Service Technical Information

MODEL NO.	
	NSX–S222 / S555 series
SUBJECT	
	No compatibility between 4ZG–1 and AZG–1Z8

REF.No. :G – 99 – 050 – E0

DATE :02. NOV. 1999

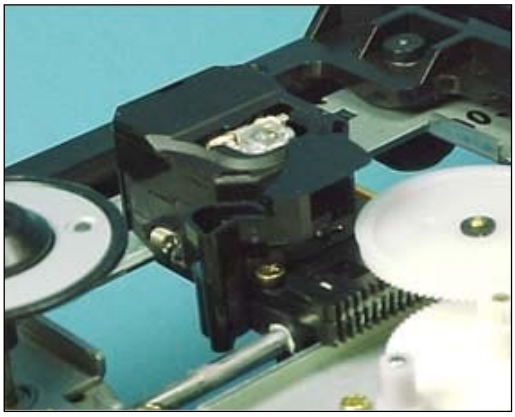
Two types of CD mechanisms, 4ZG–1 and AZG–1Z8, are used in NSX–S222 and S555 series products.
When repairing the products, note that pick-ups and microcomputers used in 4ZG–1 and AZG–1Z8 are not compatible with each other.

The pickups used in AZG–1Z8 (KSS–880) are supplied in chassis ASSY (KSM–880CAB).
Replacement of the whole chassis ASSY is required to replace the pickup.
